GREAT ARTESIAN BASIN RECHARGE SYSTEMS AND EXTENT OF
PETROLEUM AND GAS LEASES

SECOND EDITION

WITH RESPONSE TO MINISTERIAL REVIEW

Prepared for
THE ARTESIAN BORE WATER USERS ASSOCIATION

Appendix 1: Review of Revised Edition by NSW Minister for Water

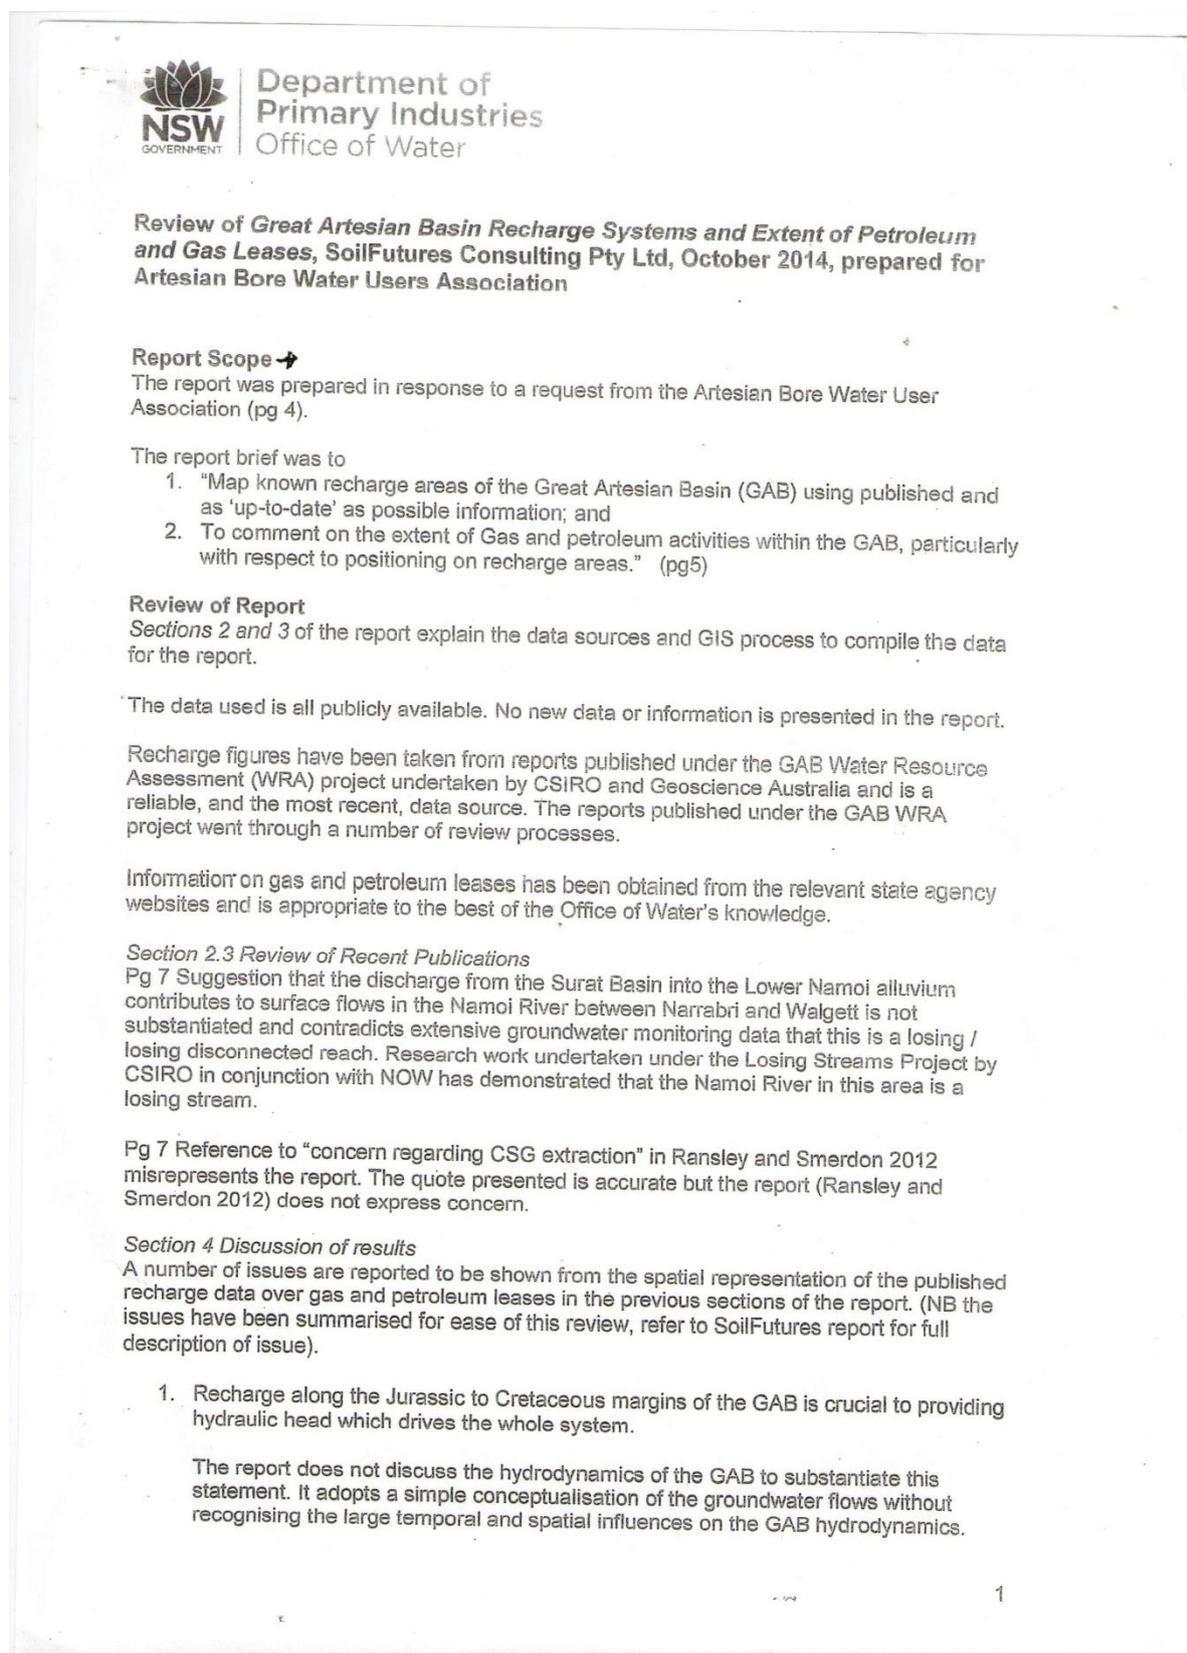
There is a significant lag in the transfer of pressure changes in the GAB due to the size of the groundwater system. The magnitude of the pressure impacts also diminish with distance from the applied stress.

As explained in Ransley and Smerdon 2012, groundwater stored in the GAB is a legacy from higher recharge rates that occurred during much wetter periods in the early Holocene and Pleistocene age.

2. Recharge is more limited than previously thought.

Given the recharge figures are based entirely on published data this statement is not supported by the published hydrogeology of the GAB.

3. Points 3 to 5 refer to percentage of "effective recharge which maintains the pressure head on the bulk of the GAB".

A simple model is presented and significant contributions to the hydrodynamics are ignored. Given the area of particular interest to this report are the NSW recharge areas it is of little consequence that contributions in central and northern Queensland are not considered. Expressing this selected recharge as a percentage of the whole of the GAB without including other contributions to the groundwater flow systems distorts the significance of the data. However, the general point that the relative area of the GAB that receives diffuse rainfall recharge is small when compared to the entire GAB is valid.

4. Reference to many hundreds of metres of drawdown in the Surat Basin in Queensland (ie the Walloon Coal Measures) is correctly quoted. Note the Walloon Coal Measures are not present in the Coonamble Embayment of the Surat Basin in NSW.

5. "Draw down in excess of 1000m is proposed in the Pilliga in the south eastern Surat Basin (ICSG Forum, 2014)".

This reference is not available, and this statement could be misleading by suggesting that this level of drawdown is predicted in the GAB in the Pilliga region.

Information provided by Santos in support of development applications for pilot production in the Narrabri Gas Project does confirm that pressure drawdown in the order of 1,000m is predicted expected in the Maules Creek Formation of the Gunnedah Basin at CSG production bore sites. The report does not clarify that the predicted drawdowns relate to the target CSG production zone of the underlying Gunnedah Basin and not the Pilliga Sandstone of the south eastern Surat Basin. Reference to Pilliga in this point is geographic and not associated with the Pilliga Sandstone of the GAB.

6. Reference to "Excessive drawdown of pressure heads in the recharge zone.....potentially stopping the free flow of waters to the surface at springs and bores".

This broad statement is not constrained geographically (eg Qld gas fields or NSW recharge area) nor does it clarify the depth to which the inferred pressure heads relate (Surat or Gunnedah Basin) to enable the context of the implied impacts to be assessed. It again assumes a simple model of the GAB and does not recognise the long response times of regional impacts.

This section appears to state opinion and apart from repeating previously noted interpretations does not purport to be presenting information of the GAB.

In the discussion of what should be considered in the management of the GAB the author has not referred to the specific management of the GAB recharge areas within NSW, including:

- all take of groundwater from the GAB has to be accounted for against the extraction limit set by the *Water Sharing Plan for the NSW Great Artesian Basin Groundwater Sources 2008*, and
- the NSW Aquifer Interference Policy sets a minimum impact consideration of 15m of drawdown within the Southern Recharge Groundwater Source and that any flowing bore should not cease to flow.

The reference to the concept of "Wasserschutzgebiet" in Germany appears to misunderstand the typical use of this as a management tool. It is used to declare recharge protection areas around municipal bore fields to prevent contamination from activities in the vicinity of the well heads. It is typically done at the scale of tens to hundreds of metres.

The conclusions of the report appear to be based on general perceptions rather than a detailed understanding of the hydrogeology of the GAB. It also does not discuss the current NSW planning and policy frameworks under which the GAB and potential impacts to it are managed. A discussion on the current management of groundwater impacts would have been beneficial to the Artesian Bore Water Users Association providing them with a sound basis on which to discuss their concerns on potential impacts of CSG developments on the GAB.

<p>Issue: Page 1. No New information is provided in this report</p>
<p><i>Response: Although all data presented in this report is public domain, no single agency in Australia has compiled the data in this form to show the extent of petroleum, coal and CSG related activities in the GAB. This is new information – a new map compiled using the best available data.</i></p>
<p>Issue: Page 1: Comment re Namoi being a gaining or losing stream Narrabri to Walgett, using the Losing Streams Project (Lamontagne et al 2011).</p>
<p><i>Response: Whilst this is an interesting comment, the study area for this report is a 3km degrading stretch of river starting 12 km from Narrabri. It does not negate or hold in doubt question data also presented in Ransley and Smerdon (2012) which shows that the Namoi alluvial aquifers closer to Pilliga are gaining waters from the GAB.</i></p> <p><i>It also appears from the wording of this that the revised edition of this report (SoilFutures, December 2014) was not reviewed, despite being provided to the NSW Minister for Water on 5th December, 2014.</i></p> <p><i>Lamontagne et al (2011) references a very small and eroding section of the Namoi River where as Ransley and Smerdon (2012) refers to more regional upward pressures into the Namoi Alluvial aquifers near Cuttabri which is between Narrabri and Walgett. There is no conflict here and the findings of Lamontagne et al (2011) needs to be considered in the context of the entire stretch of river mentioned. Clearly the reference quoted in the Ministerial Review is older than the reference quoted in the document.</i></p>

<p>Issue: “Reference to Concern”</p>
<p><i>Response: This is a moot point but as one of the reviewers of the report was the author of Ransley and Smerdon (2012) and he agreed that he was expressing concern. Perhaps this is a misunderstanding of scientific language or just semantic.</i></p>
<p>Issue: Bottom of Page 1. “This report does not discuss the hydrodynamics.....”</p>
<p><i>Response: The brief for the report did not include this. The does not present a conceptualisation of groundwater flows. It presents maps and creates new maps. There is no argument here and the point is not relevant to the document.</i></p>
<p>Issue: Page 2. Recharge is more limited than previously thought</p>
<p><i>Response: Traditionally, the recharge for the GAB has been thought to be 30% of the basin, and that it was significant. The recently published information contained in this report shows clearly that effective recharge (>1 mm/yr) is only 6% of the GAB. 6% is lower than 30% so it is hard to understand what the reviewer is trying to say in this instance.</i></p>

Issue: Page 2 point 3. “A simple model”

Response: *This criticism is misleading.*

Central and Northern Queensland are referenced and mapped with mention of CSG activities and impacts.

The Report does not focus on NSW – it is a GAB wide study referring to some points of interest within NSW.

The final sentence of this criticism negates the previous remarks “the general point that the relative area of the GAB that receives diffuse rainfall recharge is small when compared with the entire GAB is valid” however; the report also refers to the mountain block and alluvial fan recharge which is most common in NSW.

Issue: Page 2 point 4. “Reference to many hundreds of metres of drawdown”...

Response: The criticism says that the statement is correct so why this is mentioned is unknown. The point that this document makes is that there are known connections between the underlying Permian gas rich rocks and the Jurassic/ Cretaceous GAB aquifer and the removal of waters from the Permian rocks may result in drawdown in the Gab aquifer.

Issue: Page 2, Point 5. Reference to CSG forum and comment that this statement could be misleading.

Response: This is clearly referenced and the 1000 m drawdown is clearly available at <http://csgscienceforum.com/contributor-reports/>

Issue: Point 6, page 2. This broad statement is not constrained geographically.....

Response: The report is about the Great Artesian Basin. It is geographically constrained to the Great Artesian Basin. It is about risk, and it is not intended to provide a hydrogeological model. No such model is proposed. It is the job of the various state and federal agencies to monitor and model the GAB or the part which they have legislative authority over. There are no data or peer reviewed publications currently publically available from these agencies to

Issue: “long response times of regional impacts” not recognised.

Response: The document is about risk. Response times are not mentioned because none of the federal or state bodies have published any response times. It is interesting to note that (in NSW) over 30% of artesian bores in the GAB are no longer artesian due to pressure losses. These local effects happened within a 140 year time frame or less.

Issue: Section 5. Page 3. This section states opinion

Response: The conclusions show that there is a risk of dewatering partially connected aquifers with regard to pressure gradients in the GAB.

Issue: Remarks regarding NSW State Policy and lack of inclusion in the report

- 1. The report is not about NSW, it is about the GAB.*
- 2. The policy of a particular agency is irrelevant to the identification or existence of risk*
- 3. The agency who apparently provided the review has not published anything to do with the risk in the scientific literature so no comment on how risk is proposed to be managed is made.*

Issue: Comment on “Wasserschutzgebiet” is incorrect

Response: Obviously the reviewer has no recent knowledge on European Legislation with regard to groundwater management, not have they made contact with the relevant qualified persons in German Government (such as Dr Gredner, whose details are provided in the acknowledgements section of this document). Dr Gredner would be happy to furnish any information that the NSW Minister for Water Requires in this matter.
